# UNITED STATES PATENT AND TRADEMARK OFFICE

10/583,607

<b>Office Action Summary</b>	<b>Application No.</b> 10/583,607	<b>Applicant(s)</b> NISHIKAWA ET AL.	
	<b>Examiner</b> PHILLIP A. JOHNSTON	<b>Art Unit</b> 2881

***Detailed Action***

FIG. 3

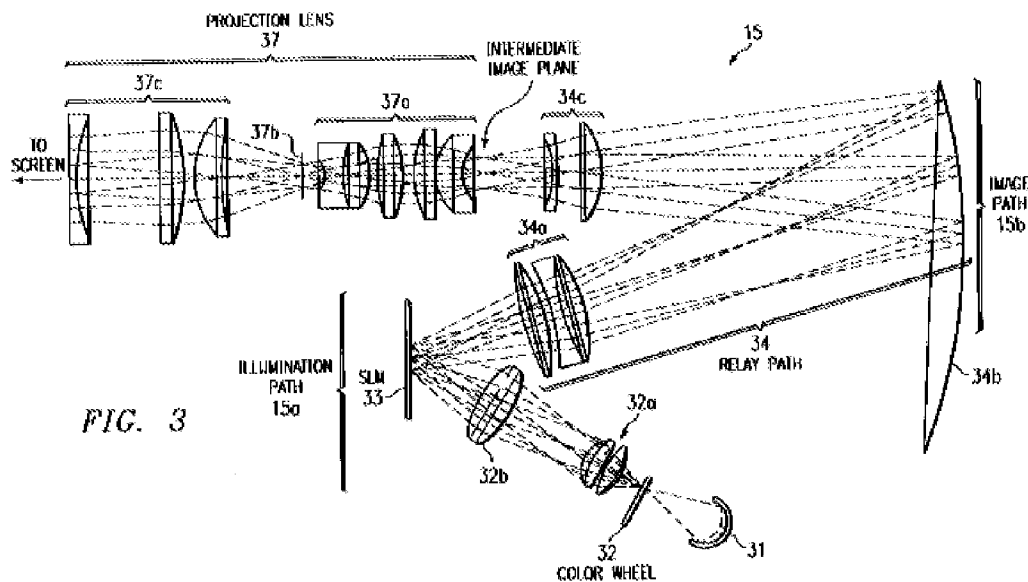
7. Regarding claim 14, Davis discloses at Col. 3, line 38-67; and Col. 4, line 1-33; the projection display apparatus shown below in Figure 3 that includes the following;

(a) Light source 31,

(b) Modulator SLM 33 that modulates the light source based on digitized video signals. See Col. 3, line 22-37

(c) A first optical system that includes the following optical elements; lens set 34a, concave mirror 34b and lens set 34c, which forms an intermediate image of SLM 33 (the primary image surface) at the intermediate image plane, of lenses 34a as shown in Figure 3 above. Col. 4, line 16-33,

(d) A second optical system that also utilizes concave mirror 34b and the optical elements of Projection Lens 37 (note Figure 3 above) to create an image on the display system screen (the secondary image surface). Col. 4, line 16-33,

(e) An optical path represented by the three ray bundles shown in Figure 3 above, which reflect from the center and extremities of modulator SLM 33 (the primary imaging surface Col. 1, line 27-43), where the light first crosses the optical axis in light path 34 then reflects off the concave mirror 34b and crosses the optical axis again at the intermediate image plane then travels through the projection optics to the screen (the secondary image surface). See Col. 3, line 38-67; and Col. 4, line 1-33.

Davis discloses a projection display apparatus shown above in Figure 3 that includes the following;

(c) A first optical system that includes the following optical elements; lens set 34a, concave mirror 34b and lens set 34c, which forms an intermediate image of SLM 33 (the primary image surface) at the intermediate image plane, of lenses 34a as shown in Figure 3 above. Col. 4, line 16-33,

(d) A second optical system that also utilizes concave mirror 34b and the optical elements of Projection Lens 37 (note Figure 3 above) to create an image on the display system screen (the secondary image surface). Col. 4, line 16-33,

(c) An optical path represented by the three ray bundles shown in Figure 3 above, which reflect from the center and extremities of modulator SLM 33 (the primary imaging surface Col. 1, line 27-43), where the light first crosses the optical axis in light path 34 then reflects off the concave mirror 34b and crosses the optical axis again at the intermediate image plane then travels through the projection optics to the screen (the secondary image surface). See Col. 3, line 38-67; and Col. 4, line 1-33.
